INFORMATION SHEET 10/13/15 TRUSTEES MEETING

ISSUE: RGM Associates Jefferson Change Order #'s and Traina Gymnasium Change Order #'s #021, #029-R1 and #030

RE: Anthony Traina Gym and Performance Center
DSA Appl. #: 02-113192
COR #021

APPLICATION FOR APPROVAL OF CONSTRUCTION CHANGE DOCUMENT - CCD CATEGORY A

ANTHONY TRAINA SCHOOL GYMNASIUM AND PERFORMANCE CENTER BUILDING JEFFERSON SCHOOL DISTRICT			DESCRIPTION: P-2.2
A#	DATE	SCALE	SHEET:
02-113342	05/08/15	1/8"=1'-0"	SKP-8

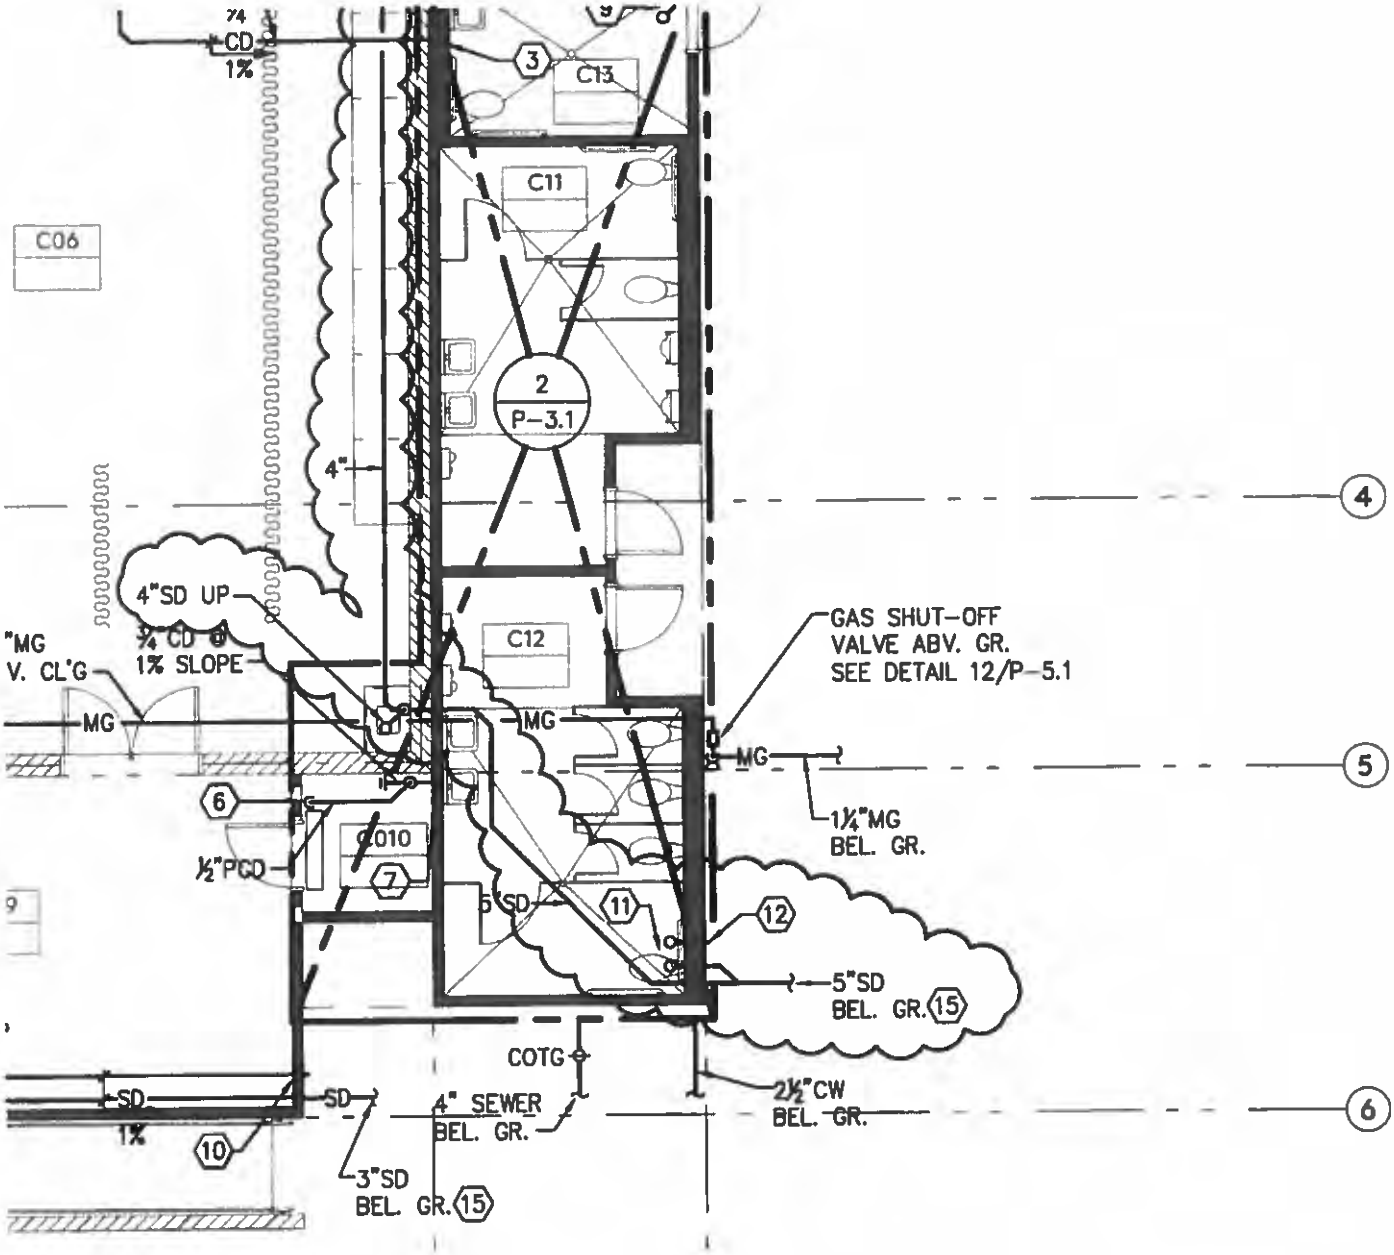
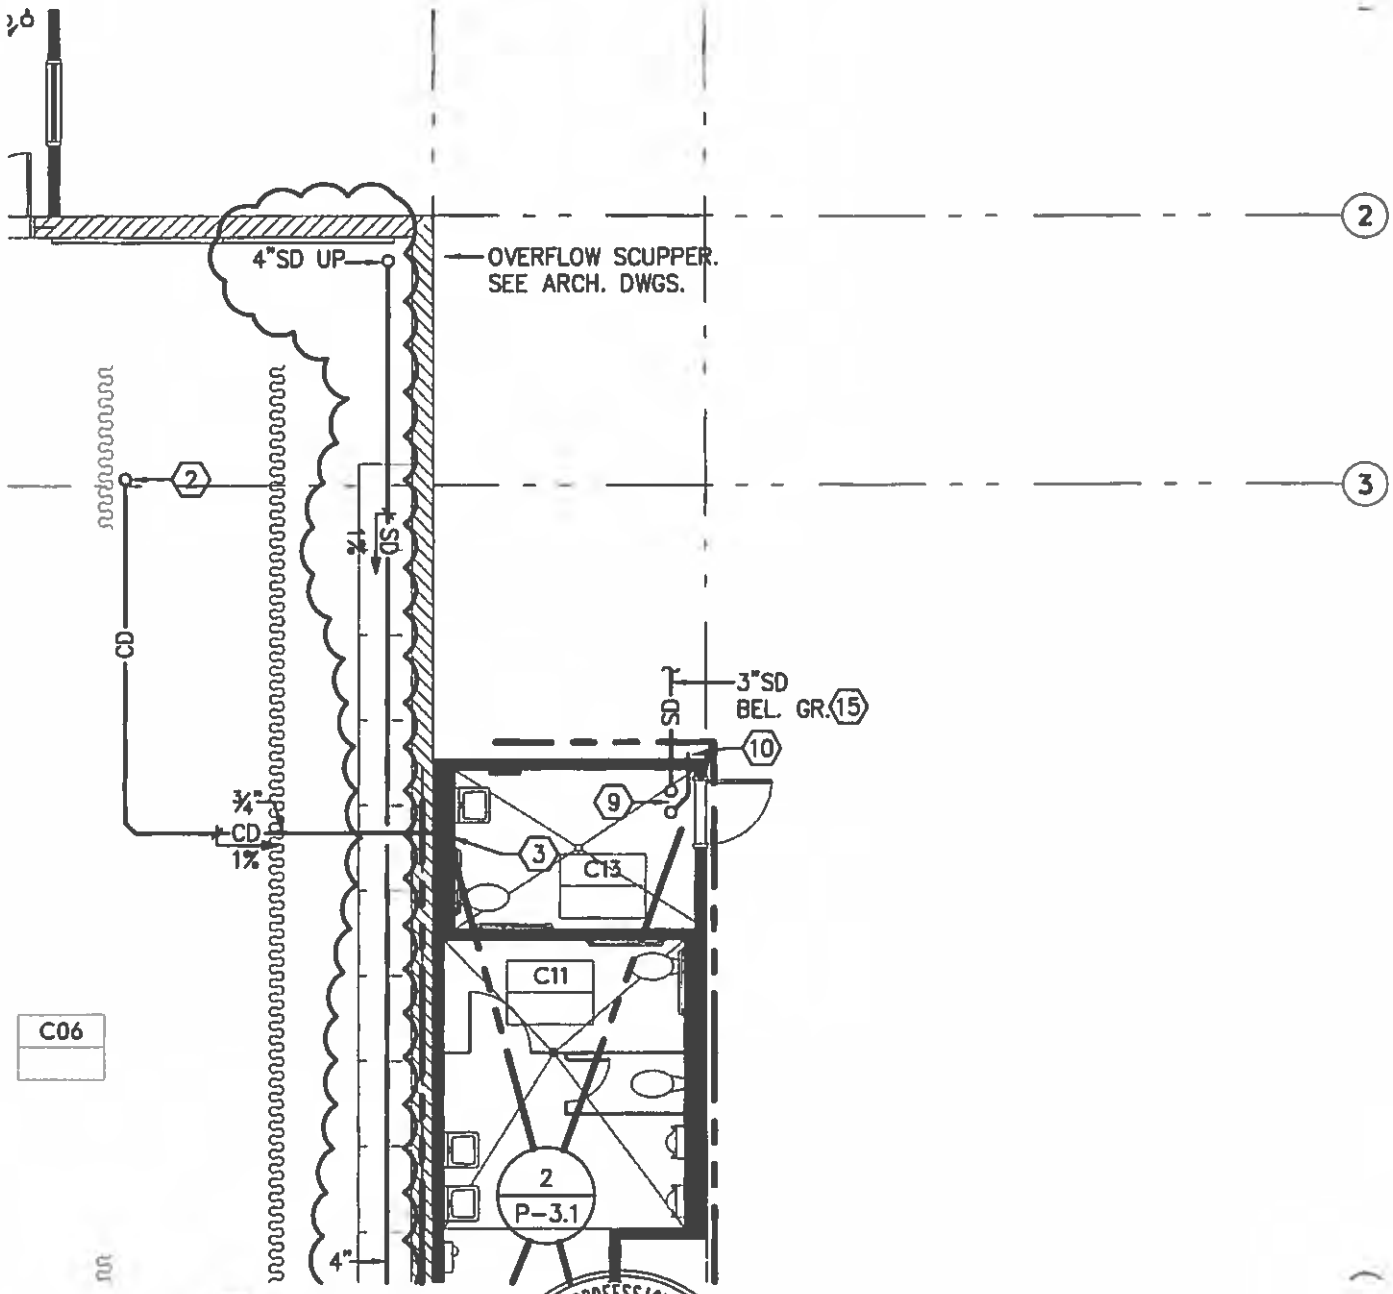
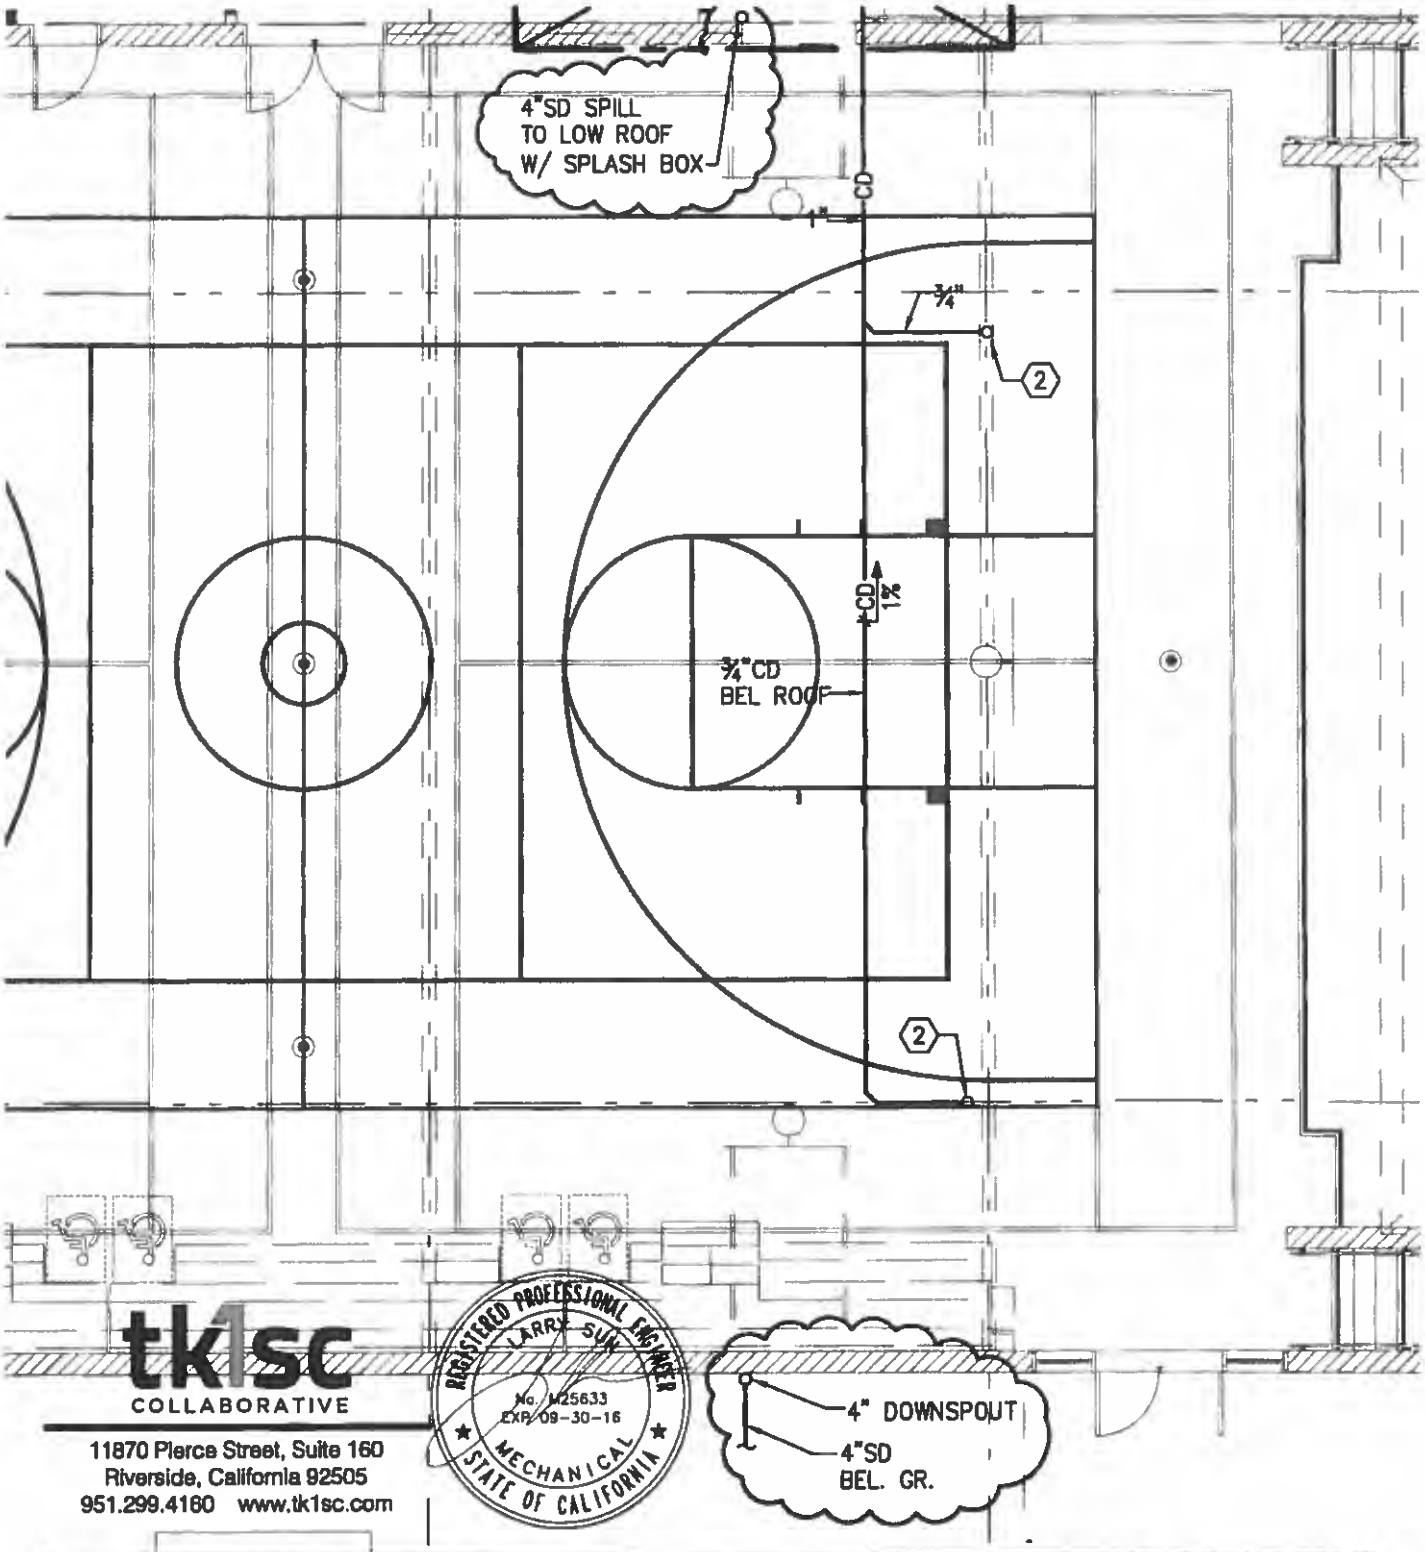
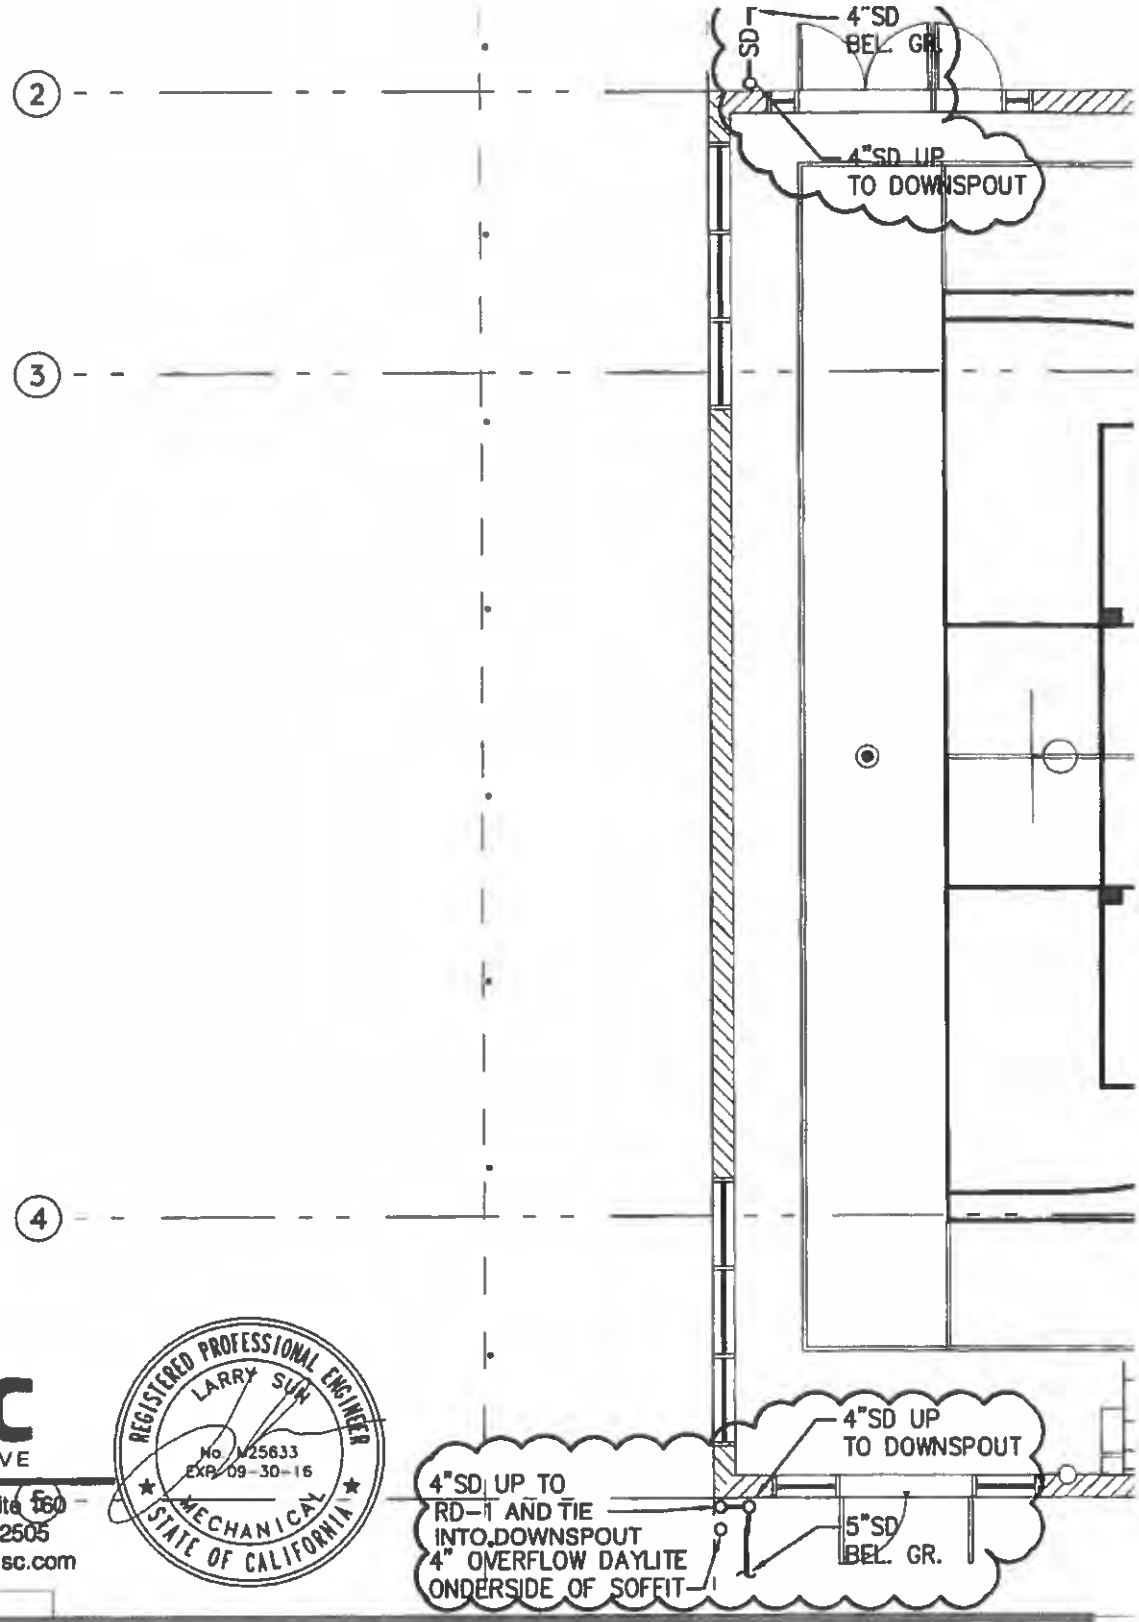
Notes: To replace roof drains with downspouts per detail SKA-1 through SKA-5, SKA-2 detail #8 & SKP-8. Add two additional roof drains and revise the storm drain connections.

Provide new storm drain connection per SKC-1. Revise the roof crickets from wood framed to rigid insulation and replace roof drains with collector box and downspouts per SKA-1 through SKA-5 . Add two additional roof drains and revise the storm drain connections per P-1 through P-8.
